V2500-A1/A5 SERIES PROPULSION SYSTEMS SERVICE BULLETIN

This document transmits Revision 3 to Service Bulletin V2500-ENG-71-0303 and Revision 3 to the Supplement

V2500-ENG-71-0303

POWER PLANT – ENGINE ELECTRONIC CONTROLLER (EEC) HARNESS-CORE – INTRODUCTION OF
VOLTAGE DIVIDER HARNESS ASSEMBLY BETWEEN THE TRIM BALANCE PROBE AND ENGINE HARNESS

Installation of the new Voltage Divider Harness Assembly
Figure 1 (Sheet 1 of 3)

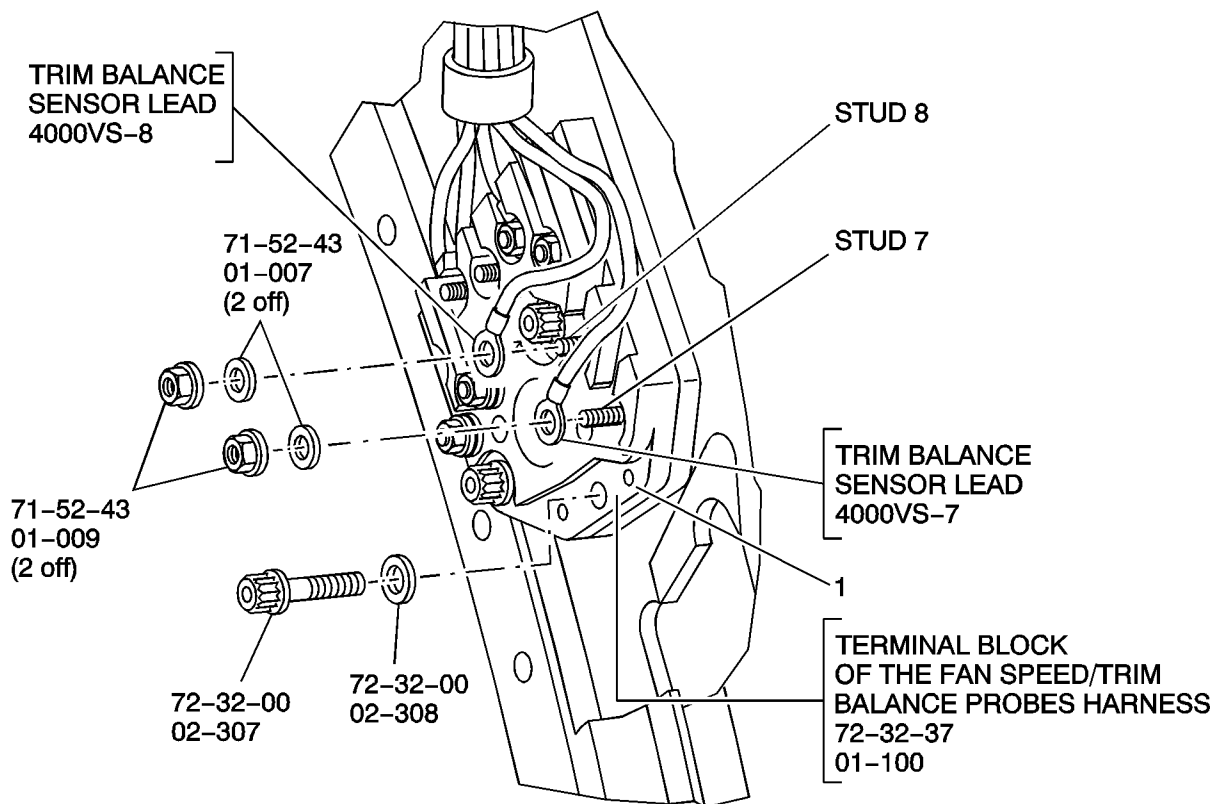
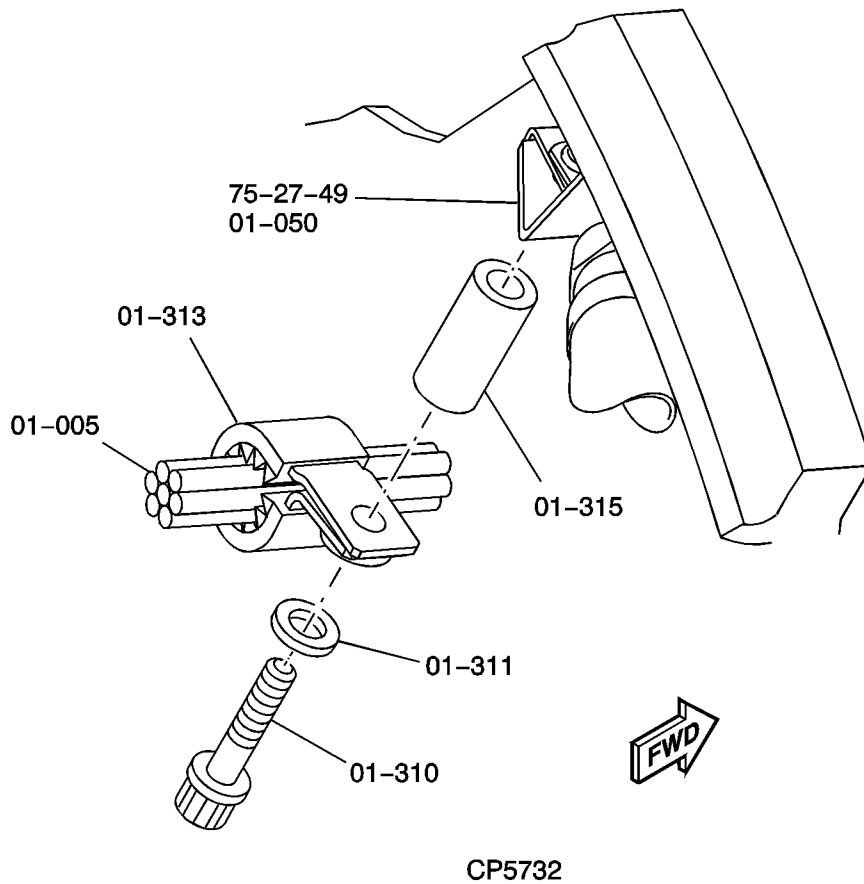
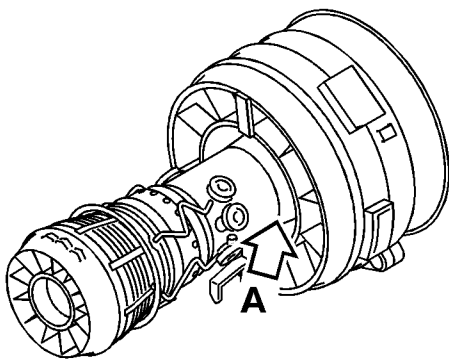
(3) Disconnect the core harness (71-52-43, 01-005) from the terminal block (1) of the fan speed/trim balance probes harness (72-32-37, 01-100) (Refer to Figure 1, Sheets 1 and 2)

- (6) Remove the parts at the clip position CP5732 from the bracket (75-27-49, 01-050) (Refer to Figure 1, Sheets 1 and 3)
 - (a) Remove the old bolt (71-52-43, 01-310), P/N 4W0112, the old washer (71-52-43, 01-311), P/N 5W1086 and the spacer (71-52-43, 01-315) that attach the clip (71-52-43, 01-313) to the bracket (75-27-49, 01-050).

Installation of the new Voltage Divider Harness Assembly
Figure 2 (Sheet 1 of 3)

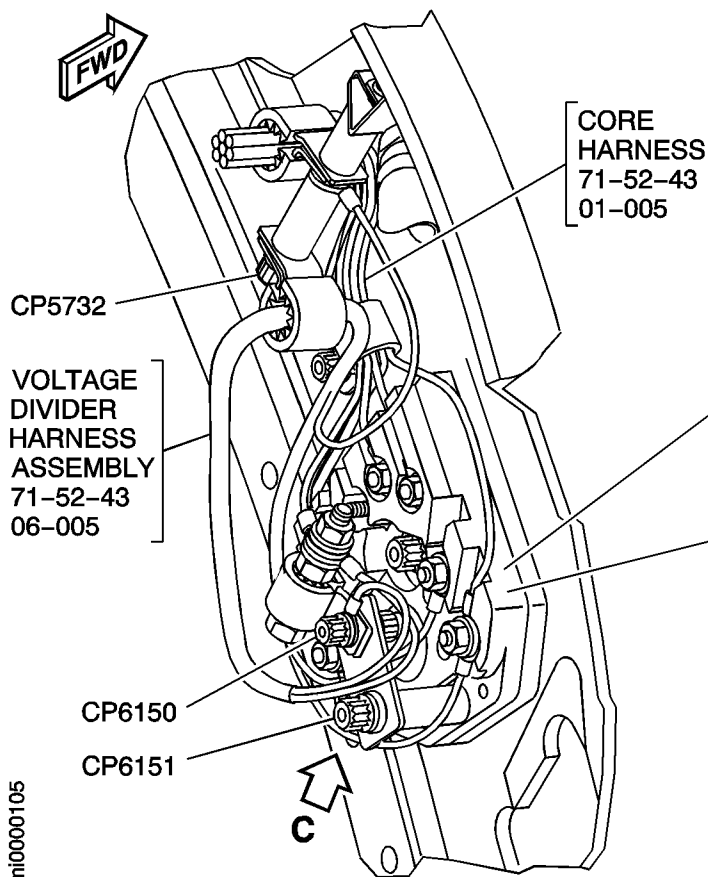
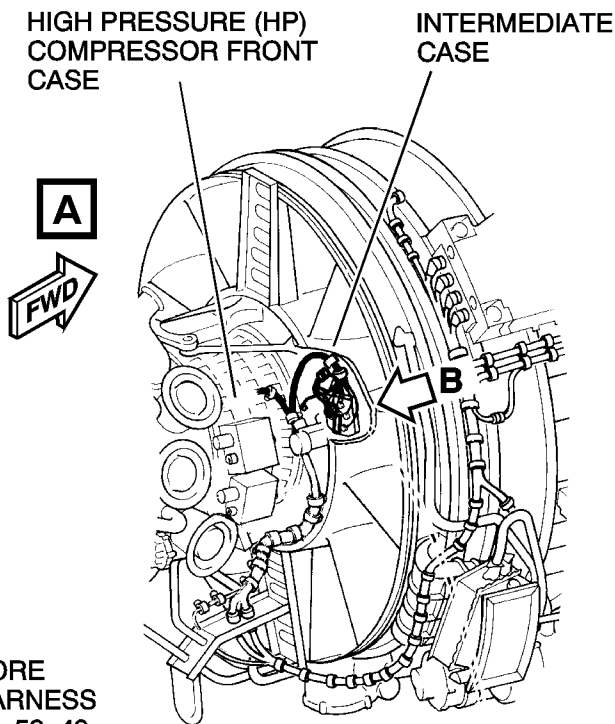
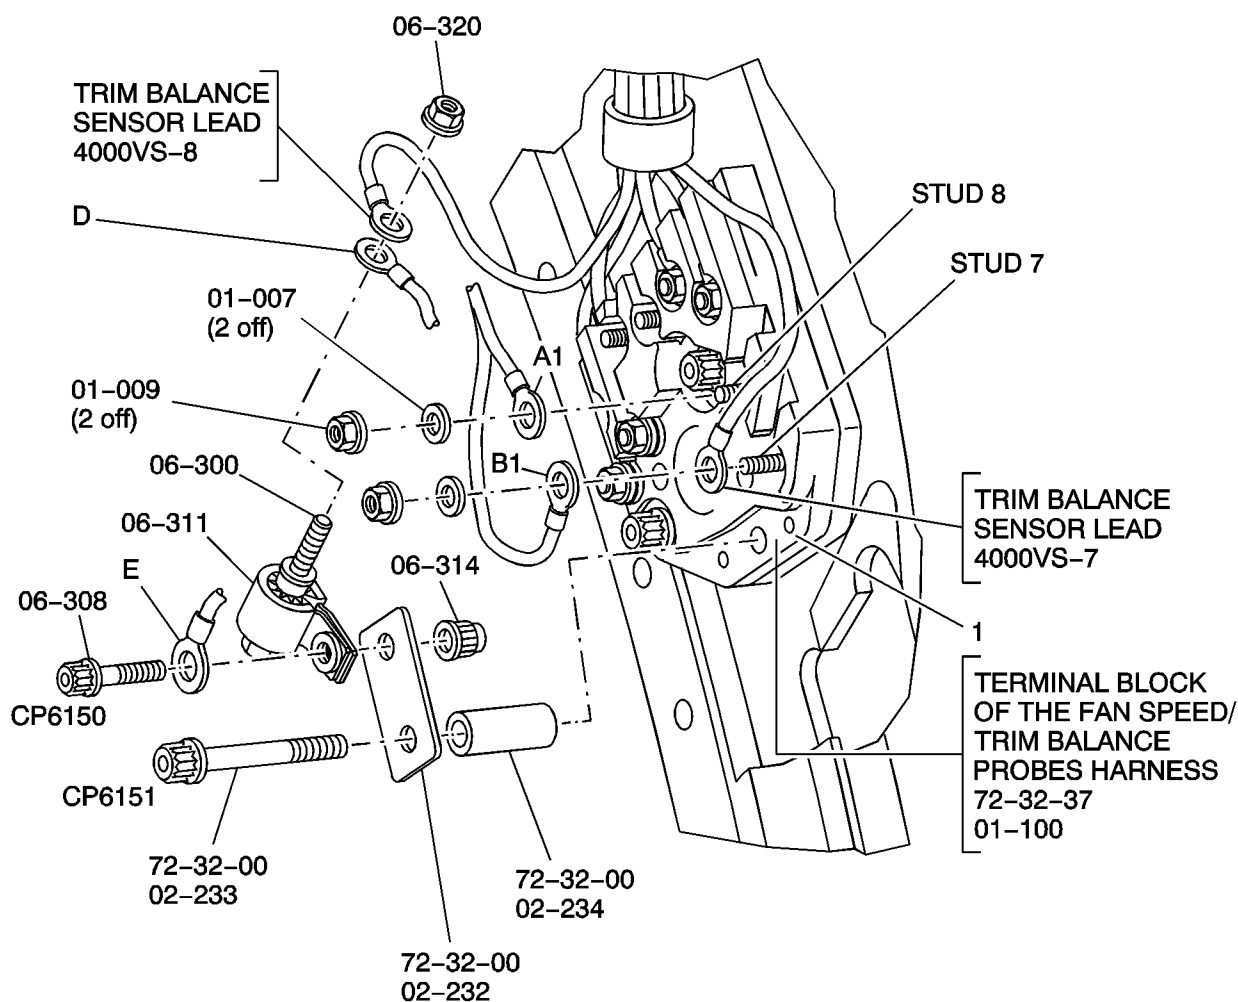
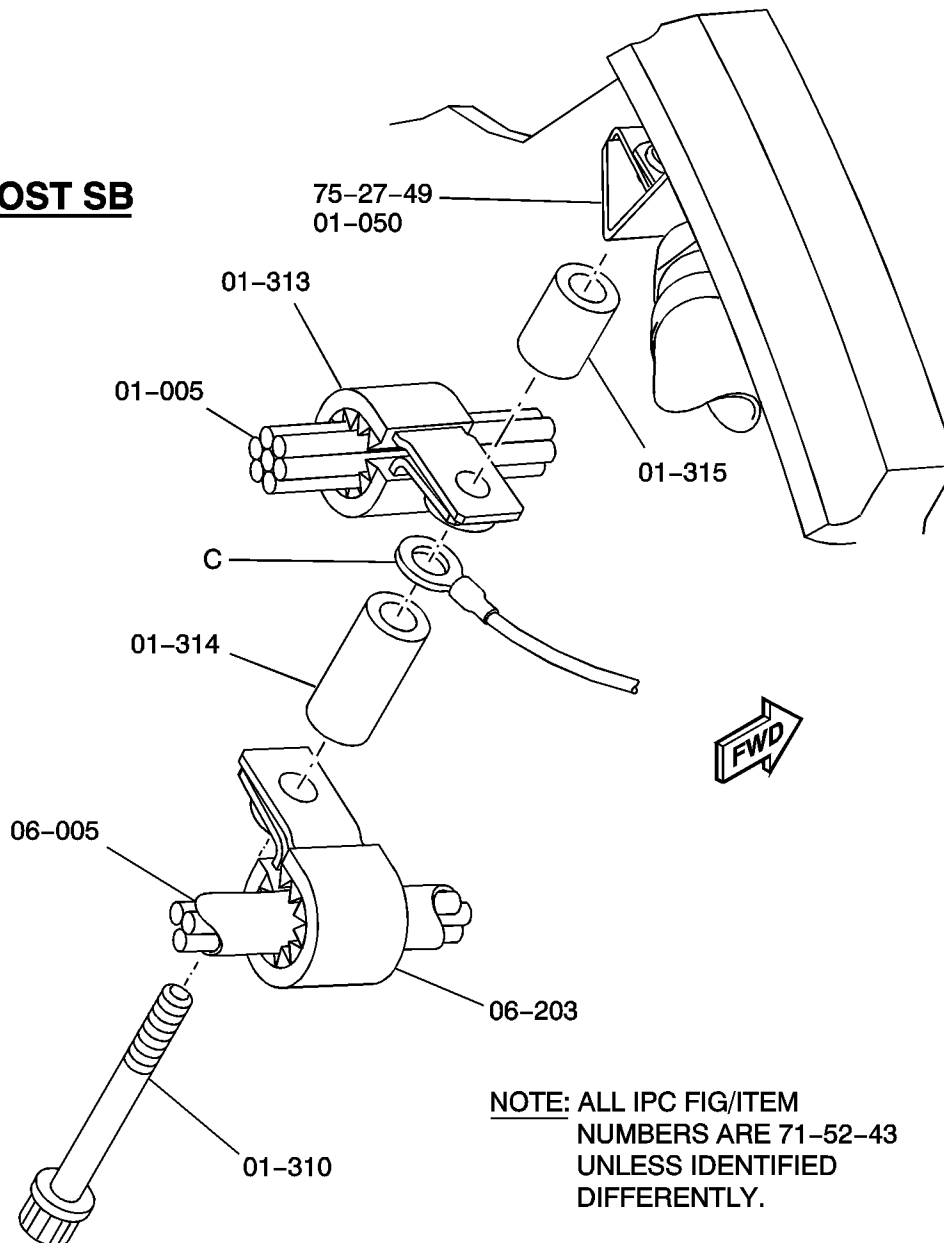
(4) Connect the new voltage divider harness assembly (71-52-43, 06-005), P/N 6A8933 and the core harness (71-52-43, 01-005) to the terminal block (1) of the fan speed/trim balance probes harness (72-32-37, 01-100) (Refer to Figure 2, Sheets 1 and 2)

- (i) Torque the nut (71-52-43, 01-009) to between 10 and 14 lbf in. (1,13 and 1,58 Nm).
- (5) Install the parts at the new clip position CP6151 on the terminal block (1) of the fan speed/trim balance probes harness (72-32-37, 01-100) (Refer to Figure 1, Sheets 1 and 2 and to Figure 2, Sheets 1 and 2)

NOTE: Do not remove the clip (71-52-43, 01-313) from the core harness (71-52-43, 01-005).
- (7) Install the parts at the changed clip position CP5732 on the bracket (75-27-49, 01-050) (Refer to Figure 2, Sheets 1 and 3)
 - (a) Install the voltage divider harness assembly (71-52-43, 06-005) into the new clip (71-52-43, 06-203), P/N AS62205.

- (c) Torque the bolt (71-52-43, 01-310) to 40 lbf in. (4,5 Nm).
 - (8) Install the parts at the new clip position CP6150 on the bracket (72-32-00, 02-232) (Refer to Figure 2, Sheets 1 and 2)
